PROJECT
 CHILD DAY CARE CENTER
 601 SOUTH HOOKINS RD.
 CHARLOTTE, N.C.

SHEET DESCRIPTION
 SITE PLAN

CHARLOTTE - MECKLENBURG PLANNING COMMISSION
 INTER - OFFICE COMMUNICATION

SUBJECT: Administrative Approval for Petition No. 93-10 by Delcencia C. Knox Tax Parcel # 063-025-22 and 063-025-21

SITE PLAN 1"=20'

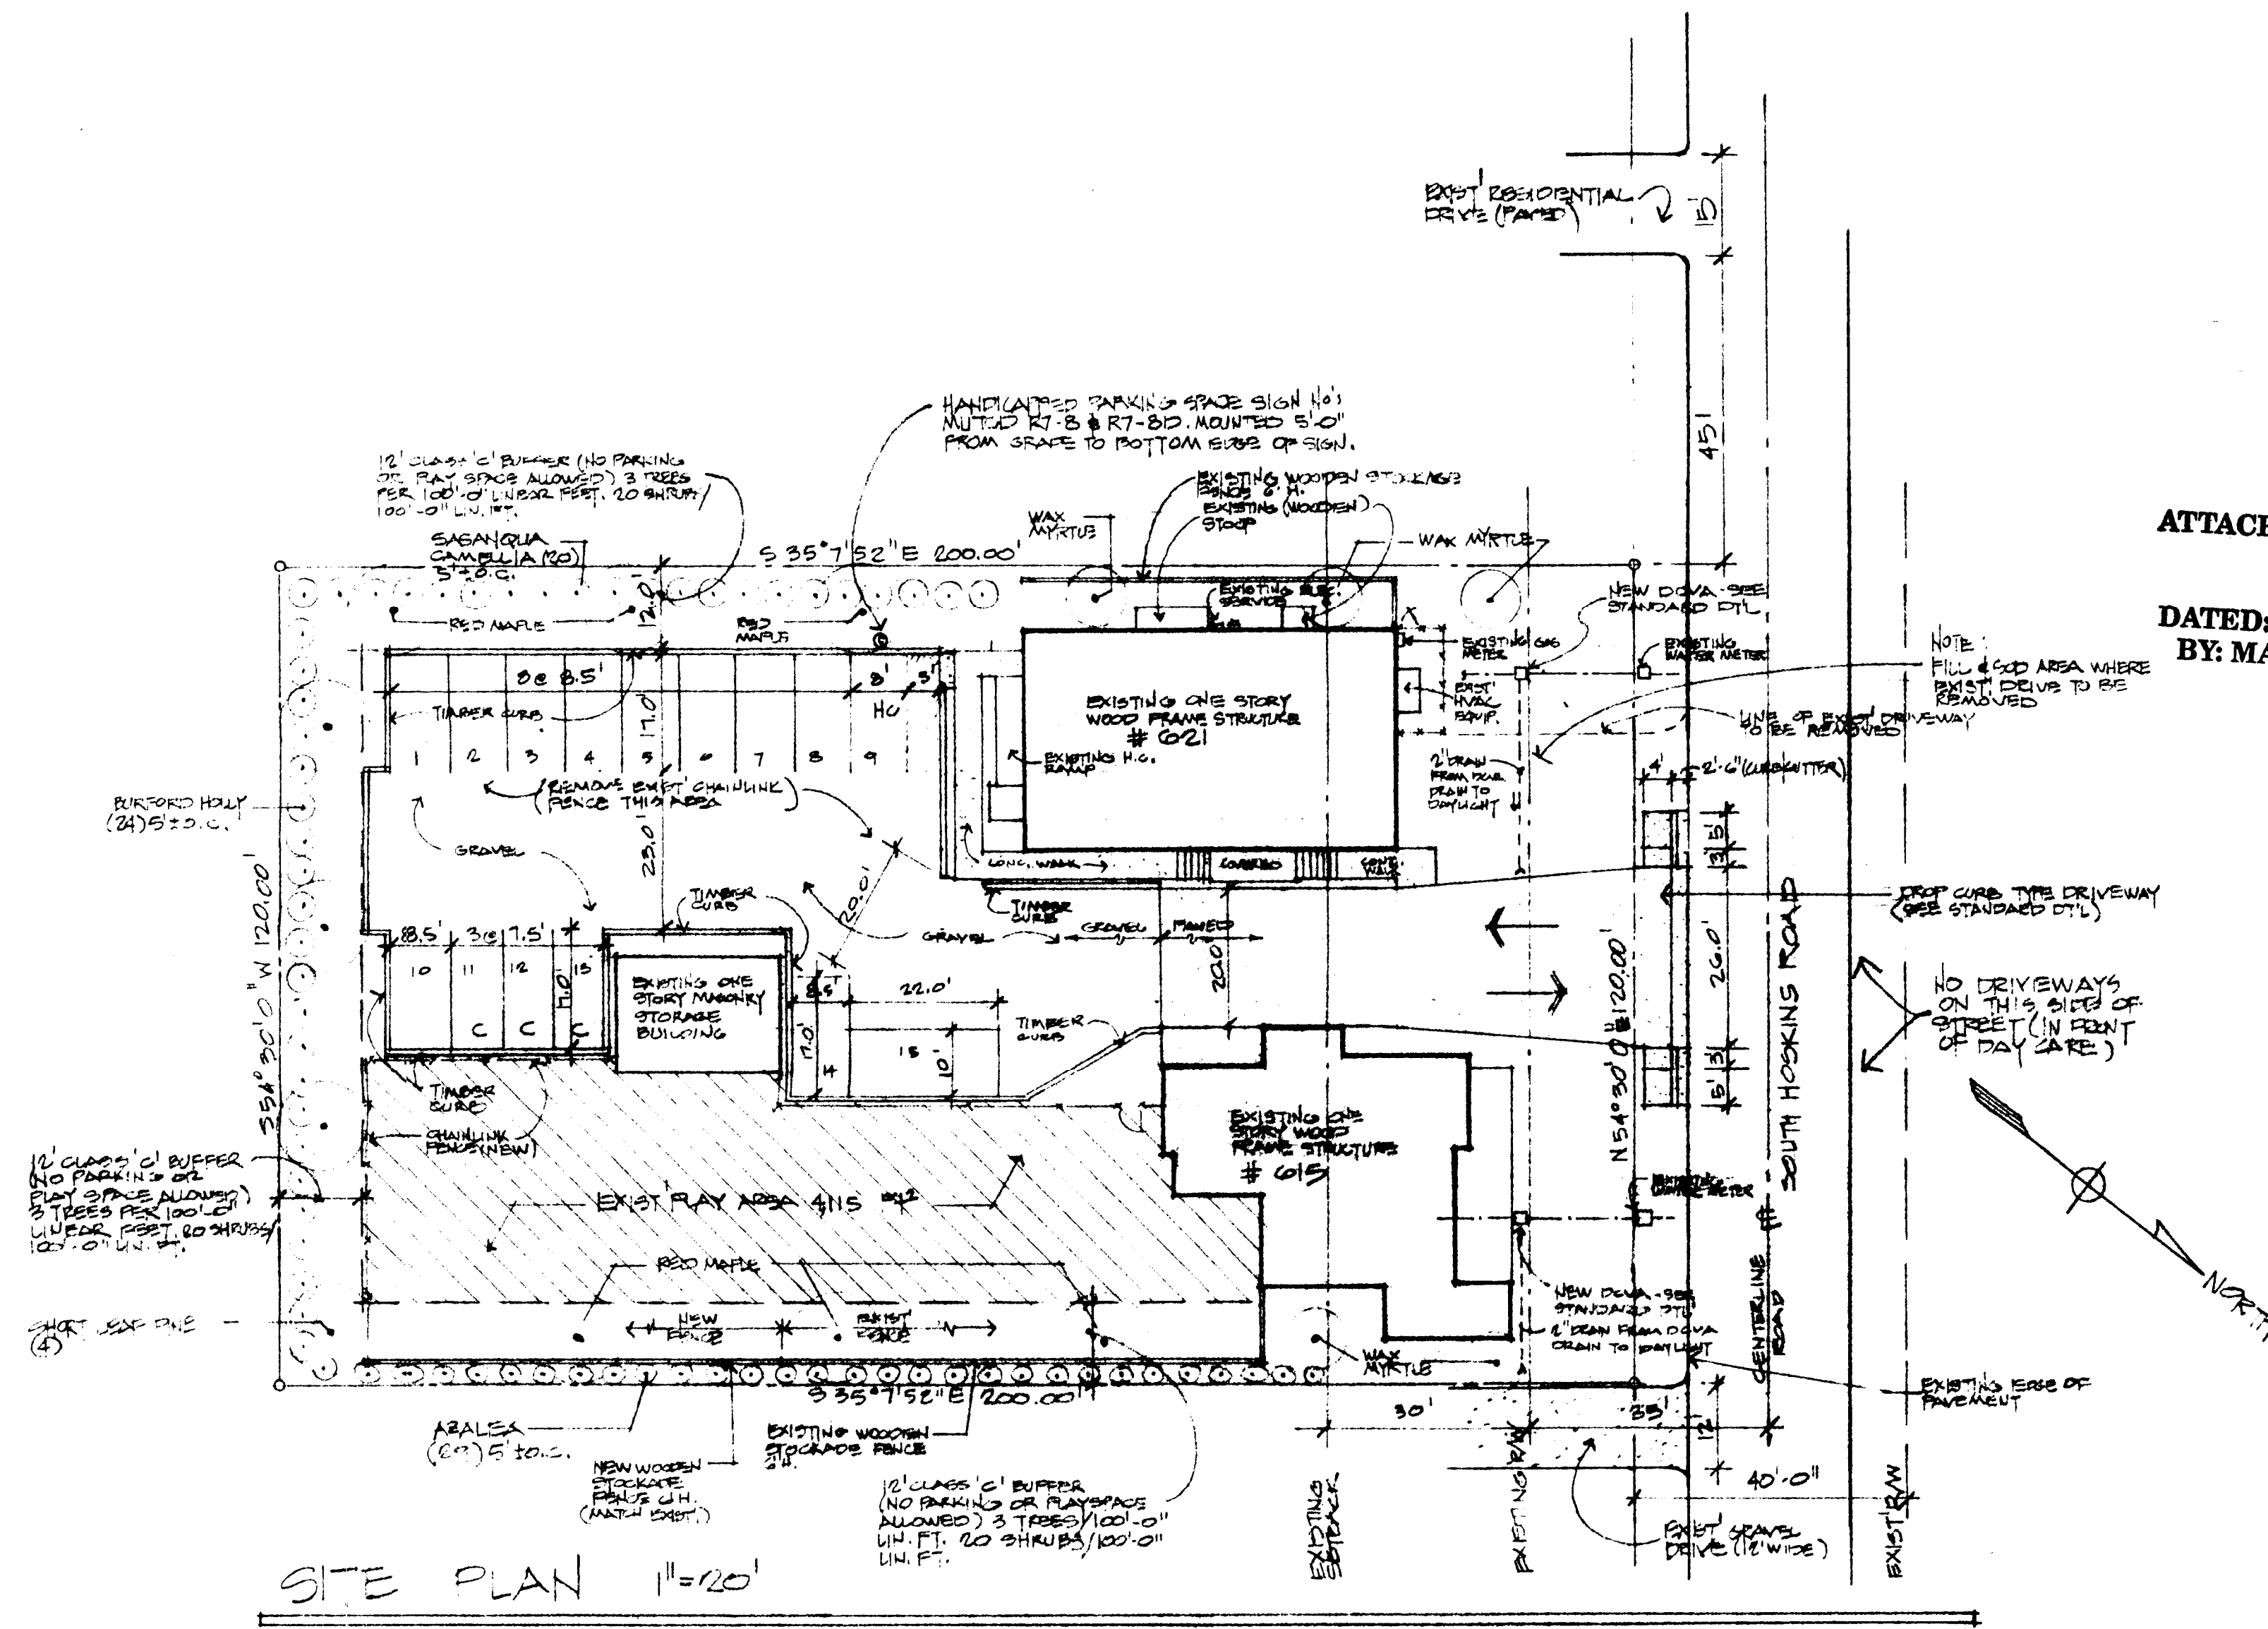
Attached is a revised plan for the above mentioned rezoning petition. The plan has been changed to allow the addition of five parking spaces to meet the parking requirements of the zoning regulations. These new parking spaces are internal to the site. These new parking spaces will not reduce the yards at the exterior of the property. Since this change is minor I am administratively approving this revised plan. Please use this plan when evaluating requests for building permits and certificates of occupancy.
